PIC16C74B Rev. A Silicon Errata Sheet

The PIC16C74B (Rev. A) parts you have received conform functionally to the Device Data Sheet (DS30605A), except for the anomalies described below.

Figure 1: $\overline{\text{MCLR}}$ External Circuit

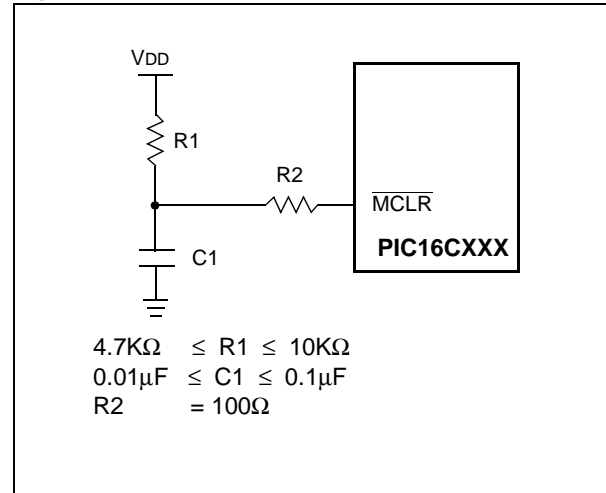
The minimum specification for the $\overline{\text{MCLR}}$ must be met in order to RESET the PIC16CXXX. If a $\overline{\text{MCLR}}$ pulse occurs that is less than the minimum specification (parameter #30), improper device operation can occur.

If the minimum specification cannot be met, then an external circuit must be used to insure that any pulse width less than the specification will be filtered before it reaches the $\overline{\text{MCLR}}$ pin.

A possible circuit is shown in Figure 1. Proper design validation needs to be done to ensure desired operation over the applications operating conditions

Figure 2: Wake-up from Sleep

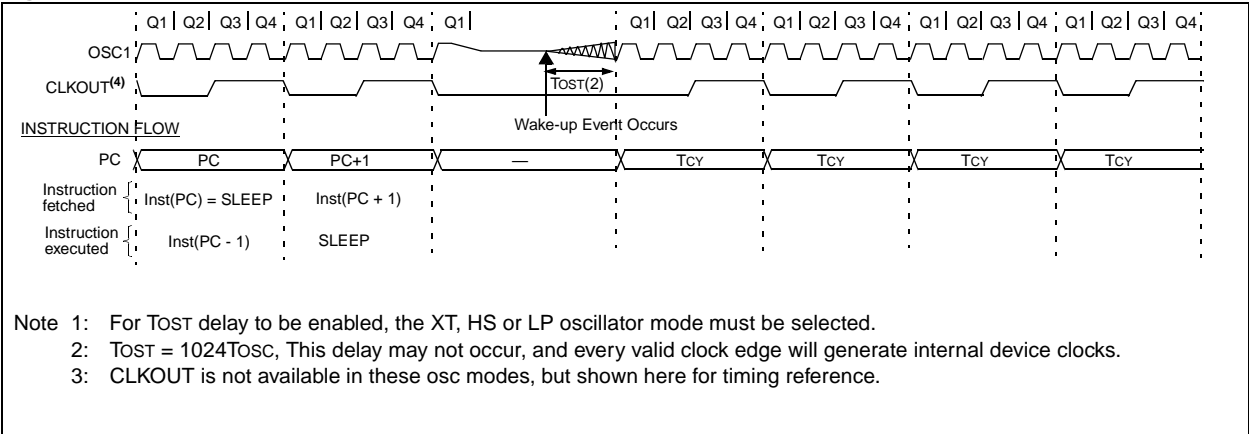
The Oscillator Start-up Timer (TOST) delay may not occur when the device wakes-up from sleep.

Figure 2 shows the start-up of the crystal after the event that causes the device to wake up from sleep mode (as specified in device data sheet). The start-up time (TOST) may not occur.

After the SLEEP instruction, do a software delay of 256 Tcy (same as 1024 TOSC). At the Reset and Interrupt vector addresses, test to see if the device woke from sleep (the $\overline{\text{TO}}$ and $\overline{\text{PD}}$ bits), and if the device did wake from sleep, ensure that the total cycle delay is 256 Tcy.

Figure 3: PIC16CXXX Voltage-Frequency Graph

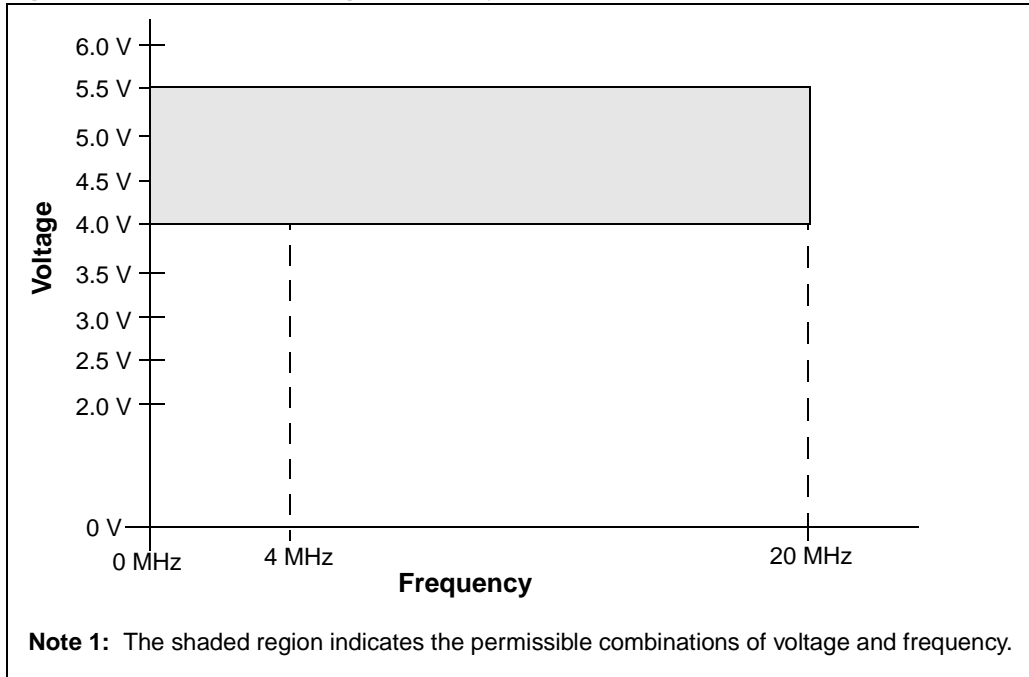
- Figure 3 and Figure 4 are additions to the data sheet to show the area of operation. These figures replace the Cross Reference of Device Specs for Oscillator Modes Table in the Electrical Specification section.

Figure 3 shows the voltage vs. frequency operation for the PIC16CXXX devices. Devices marked with a "-04" operate up to 4 MHz, while devices marked with a "-20" operate up to 20 MHz. The entire shaded region is the valid operating region.

Figure 4: PIC16LCXXX Voltage-Frequency Graph

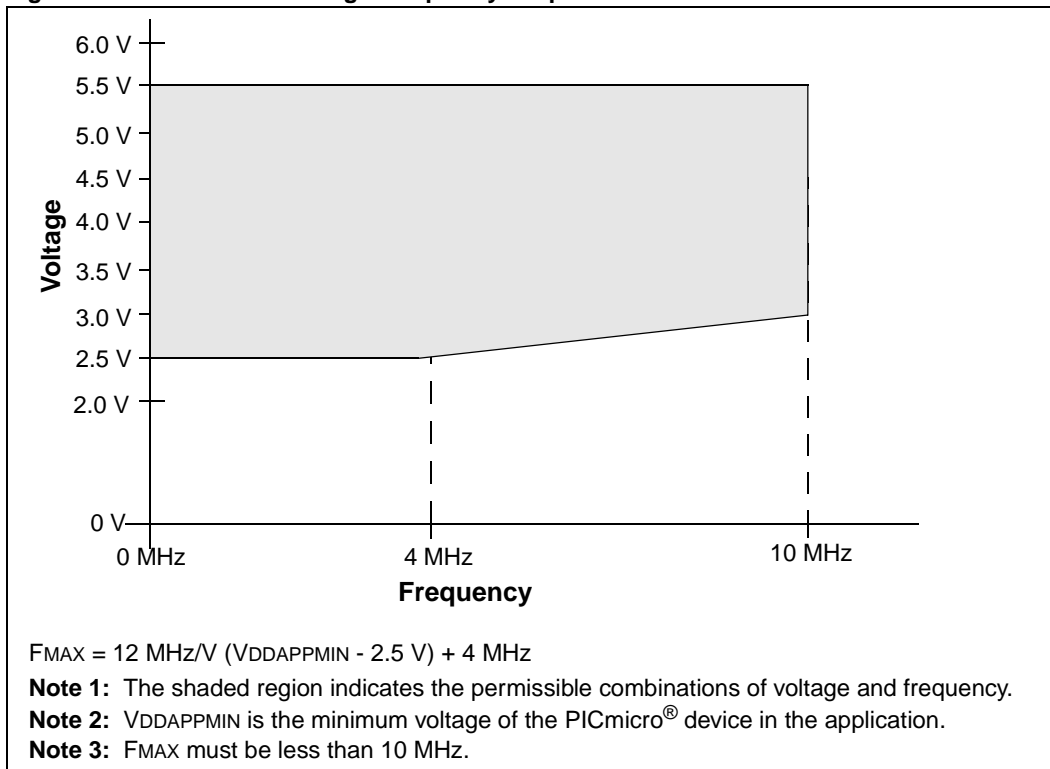
Figure 4 shows the voltage vs. frequency operation for the PIC16LCXXX devices. The devices marked with a "-04" operate up to 4 MHz at the minimum supplied voltage. The devices also operate at a higher frequency (10 MHz) and at a higher voltage (3V). The entire shaded region is the valid operating region.
